CAA Environmental Assessment

Title of airspace change proposal (ACP)	Enabling Remotely Piloted Aircraft Operations at RAF Fairford - HALE
Change sponsor	Ministry of Defence (MoD)
Project reference	ACP-2021-078
Account Manager	██████████
Case study commencement date	8 January 2024
Case study report as at	05 February 2024

Figure 3 – Proposed Amendment of EGD218 C & D (Upper Altitude to FL660)

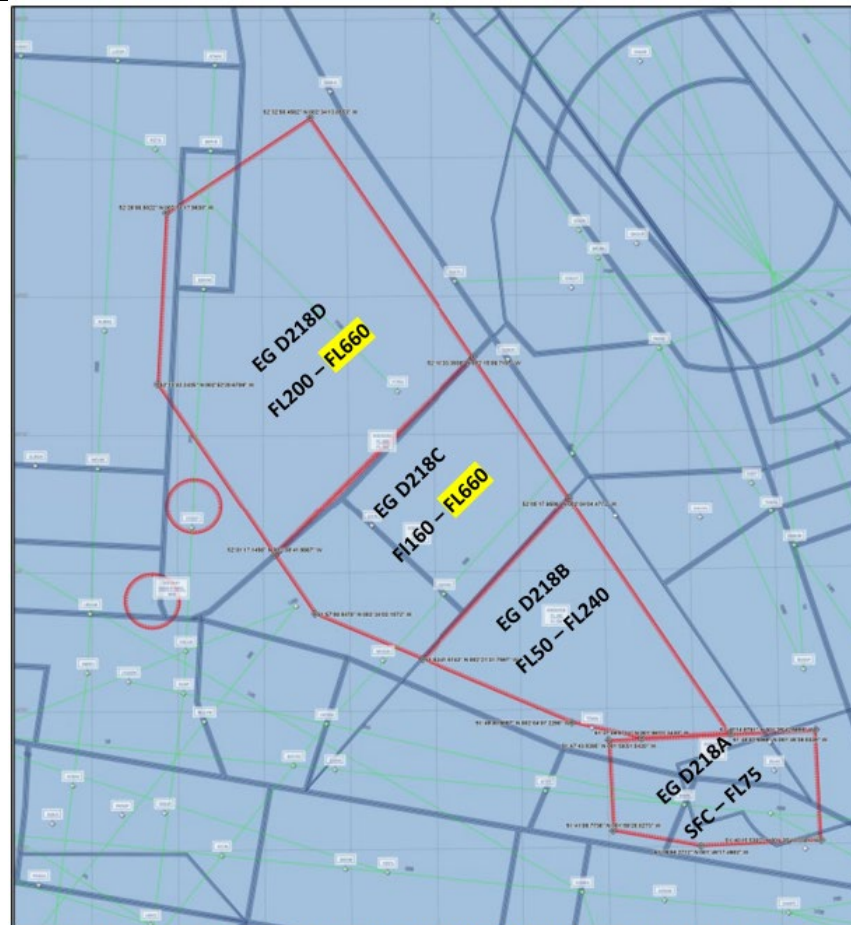
UPDATE 05/02/2024: The late change to the upper limit of segments C and D from FL500 to FL660 has the potential to change the outputs to the environmental impact assessment, specifically if the change in volume of segregated airspace impacted more civil traffic movements. The sponsor formally requested feedback from NATS on whether the assumptions that were made in the environmental impact assessment at Stage 3 would be the same based on the amended airspace. NATS confirmed that the NATS Analytical model was built using the dimensions of the TDA to FL500 with an additional 2,000 ft buffer above and below to account for the CAA SUA buffer policy. NATS confirmed that there were no aircraft identified above FL500 in the traffic sample used to inform the model outputs. Regarding the duration of activation, the change sponsor states that the flight profile of the platform is not anticipated to change, and there would be no change to the duration of activation prior to releasing the airspace.

NATS cautioned that while current usage indicates that there would no impacts associated with raising the upper level of the airspace, this did not take account of future “new entrant” civilian traffic which may operate from FL500 to FL660. The definition of “new entrant” was not specified. Whilst this may have an impact on the number of flights consequentially impacted by the proposed (amended) ACP over the 10-year forecast period, it would be difficult for the change sponsor to predict the type and frequency of those flights at this stage. Pragmatically, the number of ‘new entrant traffic’ is likely to be comparatively small with

<p>limited relative impact on fuel burn and CO₂ emissions. Therefore, based on current use patterns the environmental impact assessment is considered to remain relevant.</p> <p>The sponsor has proposed the following mitigation measures to reduce the impact of the ACP:</p> <p>Danger Area Crossing Service - The sponsor has stated that an activation window of up to 3 hours is required to provide flexibility in case the planned departure or arrival time is impacted by adverse weather or minor maintenance delays. This duration also ensures that the airspace is active in the event the aircraft needs to land shortly after take-off in an emergency or contingency scenario. In normal operations, the airspace is only expected to be in use for 45-55 minutes per activation. When possible, the sponsor proposes that the airspace will be made available to ATS providers, via a DACS, to minimize required re-routing of civil aircraft around the Danger Area.</p> <p>Reduced Activation Window - The Sponsor agreed to a NATS request to reduce the original activation window (1 hour after sunset to 1 hour before sunrise) to 20:00 - 05:30 UTC to avoid peak traffic periods. This equates to a 4.5-hour reduction in the activation window during the winter months. Using the traffic samples from the winter hours scenario, the sponsor has calculated that this would reduce the average number of aircraft impacted from 6 to 3.6 per hour. This reduction is due to an average of ~10 aircraft per hour no longer being impacted between 17:00 - 20:00 and 05:30 - 07:00. Whilst the Sponsor intends to operate only during the reduced window, they also wish to retain the option to utilise the full extent of the activation window to allow for operational flexibility in the event of an unforeseen urgent defence requirement. This is expected to be a rare occurrence but cannot be accurately estimated at this time. Consequently, the change in fuel burn and CO₂ emissions associated with this proposal has not been provided.</p>

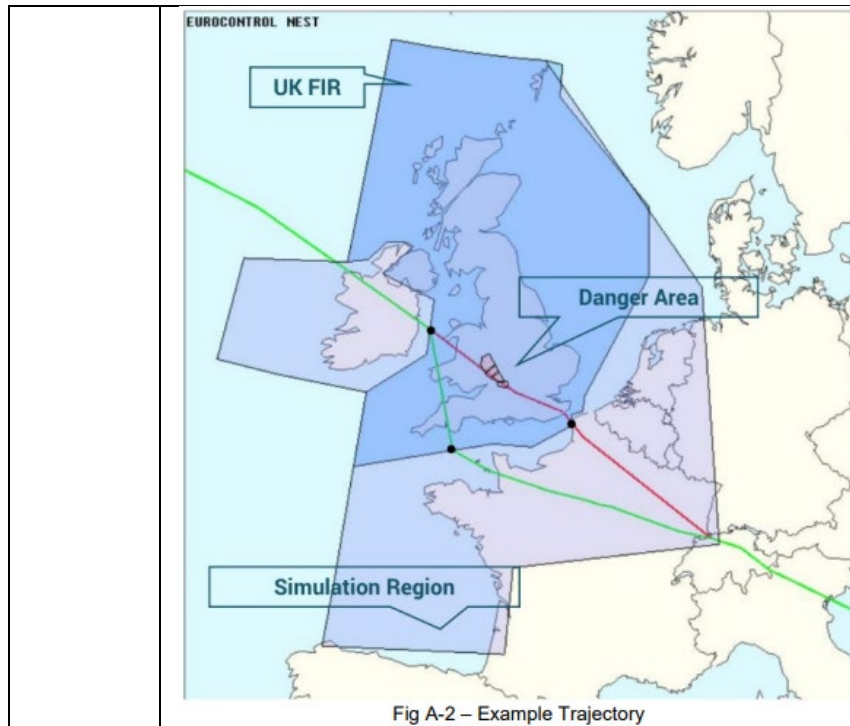
<p>up to date and credible data and modelling in line with relevant best practice however, there were some gaps in the assumptions made for the modelling inputs and an error in the calculation of fuel burn and CO₂ emissions was identified with the model outputs being 10x higher than anticipated.</p> <p>The sponsor subsequently provided revised calculations and further information on the model input assumptions which have been accurately incorporated into the final submission document. The final submission document includes data for the proposed revised activation period (20.00 – 05.30) which affords a shorter activation period than the previously modelled winter activation period (17.00 – 07.00) but longer than the previously modelled summer activation period (21.00 – 05.00).</p> <p>The source of the data for the environmental assessment has been clearly referenced. Traffic sample data was taken from 2303 AIRAC for sampling period 23/03/23 to 19/04/2023 and simulated baseline air traffic models have been produced using NEST (v1.8). Emission figures have been produced using BADA 4.2 data. The model input assumptions and output calculations have been verified and accepted by the CAA.</p> <p>The sponsor produced a Consultation Presentation at Stage 4A which incorporated diagrams of the simulated impact of the ACP on civil aircraft, calculations showing the best case and worst-case annual emissions including comparison of the summer and winter schedules, together with a simulation of additional fuel costs for civil aircraft as a result of the required re-routes. The Sponsor selected aviation stakeholders from an area within a radius of approximately 30 miles from RAF Fairford and used the National Air Traffic Management Advisory Committee (NATMAC) as a means of broader engagement plus local aviation, airline, local authority, other local and national organisations and individual stakeholders.</p> <p>The environmental assessment and the representation of the assessment in stakeholder engagement materials has been appropriate in terms of scale and proportionality based on the requirements for a Level M2 ACP.</p>

Due to the proximity of the Danger Area to the southern edge of the UK FIR (London FIR), some flights need to change their UK entry/exit point between the Baseline and Scenario simulations in order to produce a valid flight plan. Therefore, a Simulation Region was created for the study, matching the UK FIR on the Atlantic boundary but expanding across European airspace. This fixed the Oceanic UK FIR entry/exit point for any transatlantic flights, ensuring that the North Atlantic Tracks were utilised in a realistic manner. See Figure A-2: Example Trajectory.

In this scenario the flight route length was calculated to increase by 77 nm with resultant increase in fuel burn and CO₂e emissions.
